SUBJECT: REVIEW OF PRELIMINARY ACCIDENT SEQUENCE PRECURSOR ANALYSIS
OF OPERATIONAL CONDITION AT SEABROOK

LER No. 443/96-003

Event Description: Turbine-driven emergency feedwater pump unavailable because of a mechanical seal failure

Licensee Comments

Fig. 1 Dominant core damage sequence for LER No. 443/96-003.

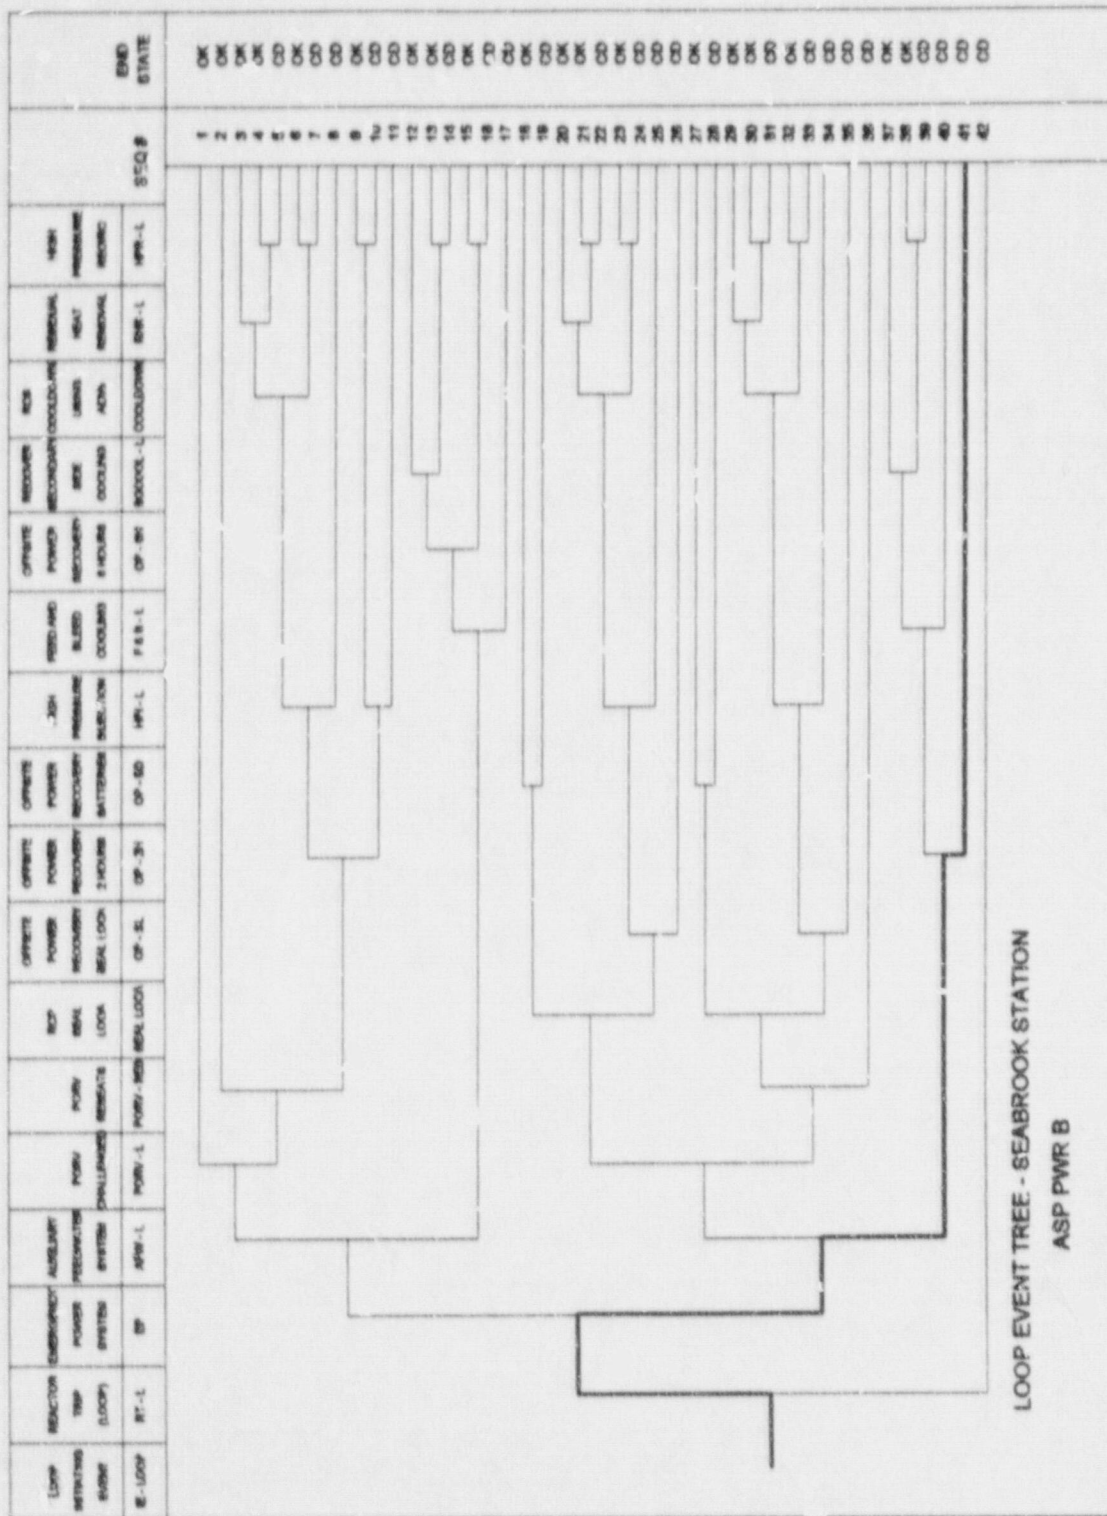
Comment 3: Sequence 39 [revised analysis sequence 41] from the Figure 1 "Dominant core damage sequence for LER No. 443/96-003" is the risk-dominant sequence in the NRC analysis. This sequence is a station blackout with failure of the turbine-driven EFW pump. In this sequence, no credit is given for recovery of electric power, presumably due to the assumption that "45 min were available before steam generator dry out would occur, leading to core damage."

Seabrook has performed analyses of this specific analysis, using the MAA^P code, with comparisons to the RELAP code results. These codes show that, for this sequence, the time to steam generator dry out is about 1.5 h, with core uncover at 2.0 h, and core overheating at 2.2 h. As a result, substantial time is available for electric power recovery. In addition, the recovery curves have their highest slope from 0 to 2 h, indicating that a few additional minutes of recovery can be significant for recovery probability. The probability for failure to recover off-site power in 1.5 h is approximately 0.25 and the probability for failure to

recover at least one of two EDGs in 1.5 h is 0.65. The overall nonrecovery probability for electric power is $0.25 \times 0.65 = 0.16$. This factor should be used in calculating the Station Blackout with EFW failure sequence.

Response 3: The assumption that "45 min were available before a steam generator dry out would occur" was used to derive a failure probability for the operator action to realign the start-up feedwater pump power supply breakers to the A EDG (basic event EFW-XHE-XM-BRKR). Based on this comment, the probability of this basic event occurring was revised from 0.16 to 0.056 to account for 90 min until a steam generator dry out occurs. If power was not recovered within 30 min, a station blackout and concurrent loss of EFW sequence was assumed to continue to core damage, as in the original modeling of the event.

However, because an additional 60 min might be available to the operators, the model was revised. A new basic event that represents recovering ac power before a steam generator dry out under blackout conditions concurrent with a loss of EFW was added to the model (basic event OEP-XHE-NOREC-SB). The probability that a source of electric power could be restored within 1.5 h given that it was not recovered within 30 min (basic event OEP-XHE-NOREC-SB) was calculated to be 0.29. Values for the probability of short-term and long-term electric power recovery for a LOOP following a postulated station blackout (SBO) were developed based on data distributions contained in NUREG-1032, *Evaluation of Station Blackout Accidents at Nuclear Power Plants* (Ref. 3 in the analysis). Based on this data distribution, the probability that a LOOP is recovered in the short term is 0.53 and is factored into the LOOP initiating event frequency. This results in an overall nonrecovery probability for electric power in the revised model of $0.53 \times 0.29 = 0.15$, which is approximately the same as the value presented in the licensee comment above.

The net effect of this model change is that the dominant sequence remains the same, but the increase in the CDP over the 3,875-h period is reduced from 1.2×10^{-4} to 4.6×10^{-5} .
